CITY OF NEWTON, MASSACHUSETTS

SUBJECT: Petition #219-97(2) of PHILIP AND ANDREA BOUCHER requesting a SPECIAL PERMIT/SITE PLAN APPROVAL for relief from FAR (Floor Area Ratio) and an amendment of the site plan approved in Board Order #219-97 Condition #1 in order to eliminate parking in the rear of the lot as required, but not implemented, to allow the petitioners to keep parking two cars in tandem on two existing driveways and allow construction of a family room addition and basement entrance at the rear of an existing two-family dwelling at 50-52 WEST STREET, Nonantum, MA, Ward 1, Section 14, Block 12, Lot 13(A) containing 6,600 square feet in a Multi Residence 2 District.

Zoning Review Memorandum

CITY OF NEWTON
ENGINEERING DIVISION

ZBA
#24-97
(AMENDED)
SITE PLAN

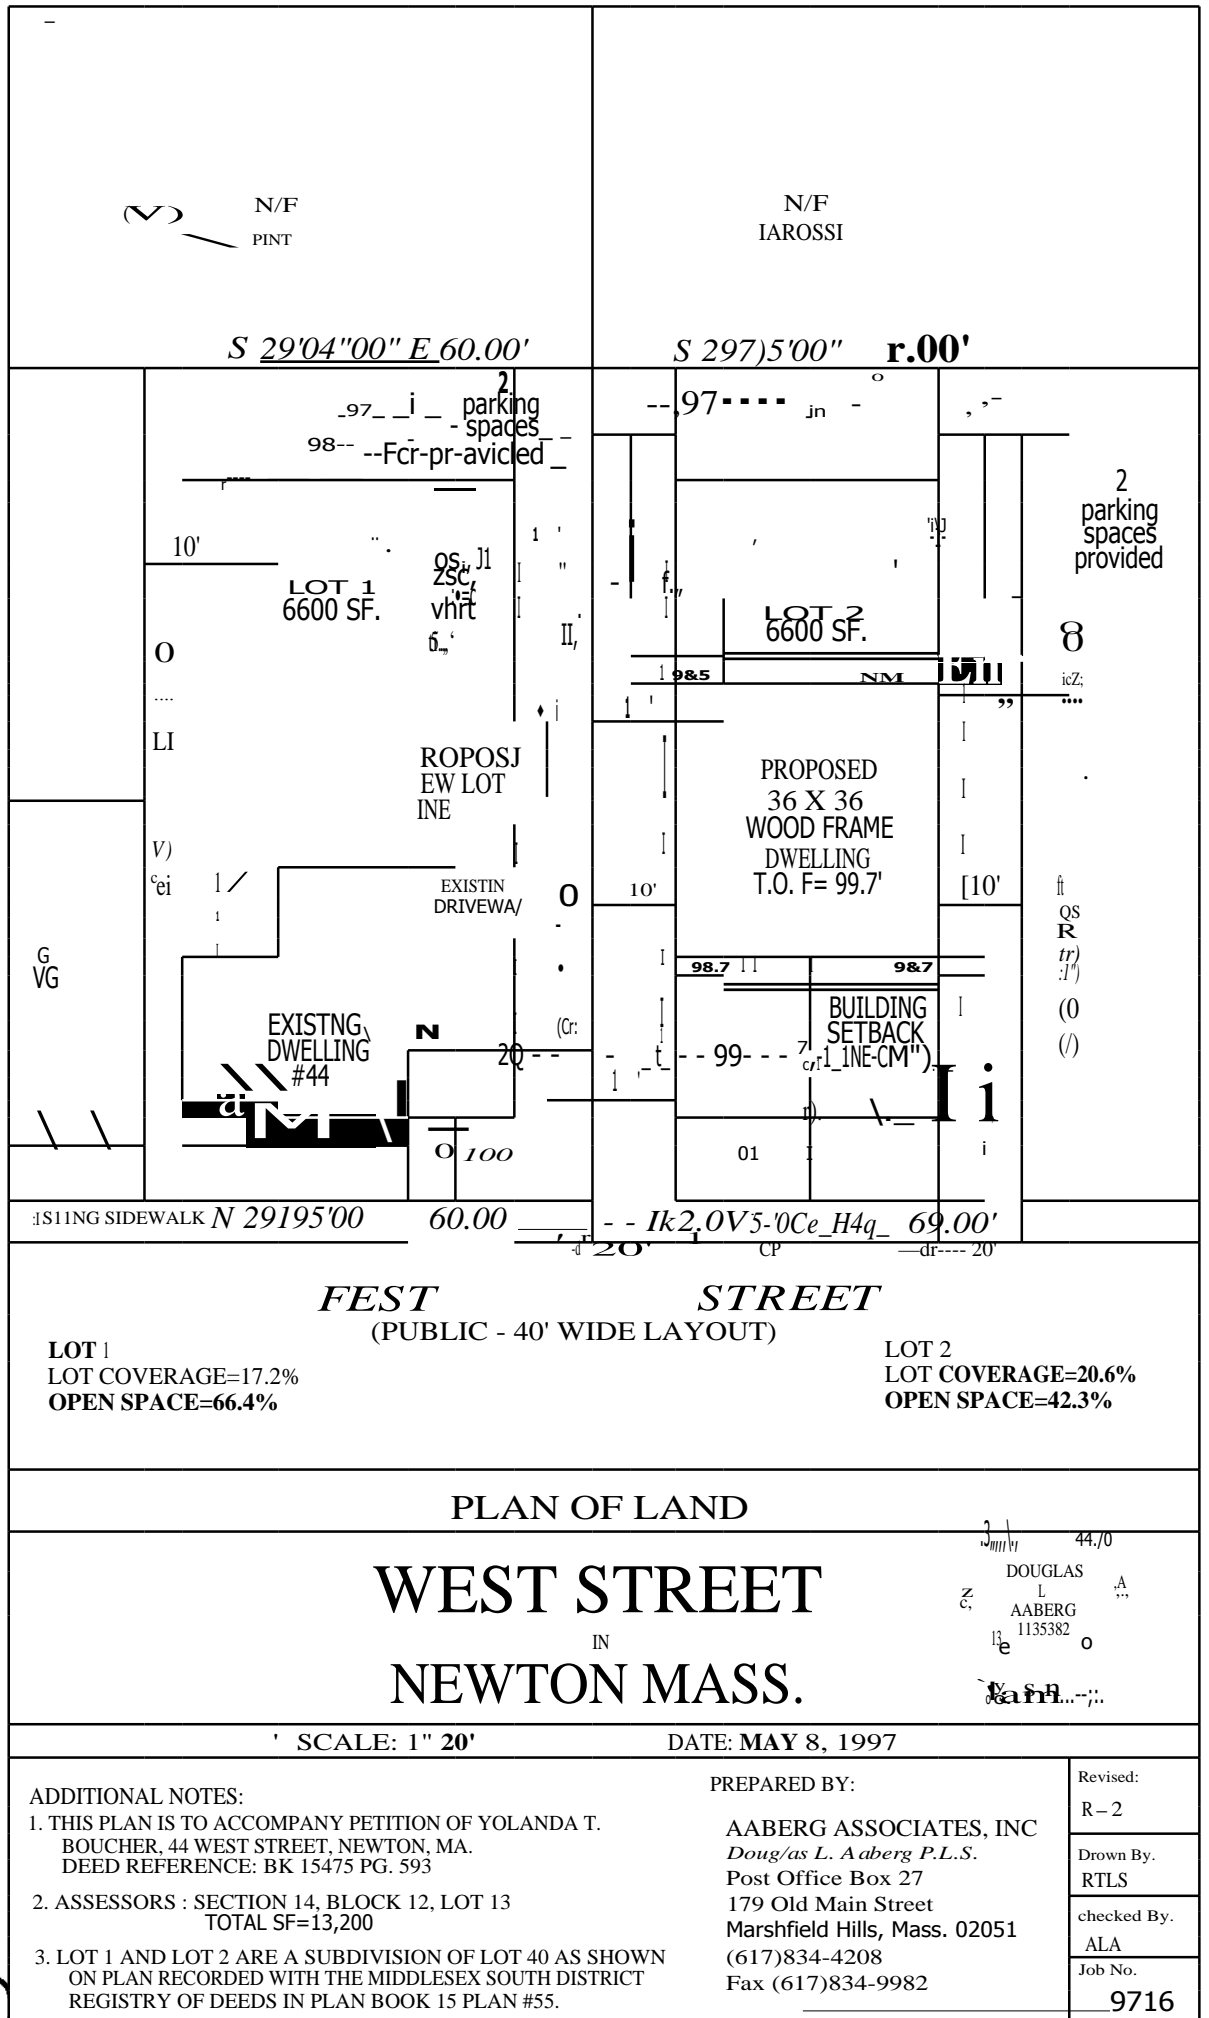
As noted by the Chief Zoning Code Official, the petitioners have not complied with either approved site plan (by the Board of Aldermen or by the Zoning Board of Appeals), which required all four off-street parking stalls to be constructed within the rear yard at 50-52 West Street. (*SEE PLANS IN ATTACHMENT "A Y*

5. As noted above, rear parking was previously required under ZBA variances #11-97 and #24-97. Certain parking layouts were authorized pursuant to separate plans approved per variance #24-97 and by special permit issued per Board Order #219-97, respectively. The proposed addition is located in an area previously required for parking raising a conflict with authorized plans. In order to build the new addition as now proposed, the rear parking requirement would need to be eliminated, necessitating amendment of the referenced variances and special permit. The rear parking requirements in ZBA variances #11-97, Condition #2, and #24-97, Condition #1 would need to be removed. Also, the BO# 219-97, Condition #1 plan of record as well as the variance #24-97 plan of record would need to be amended altering the previously required parking layouts and authorizing a new layout.
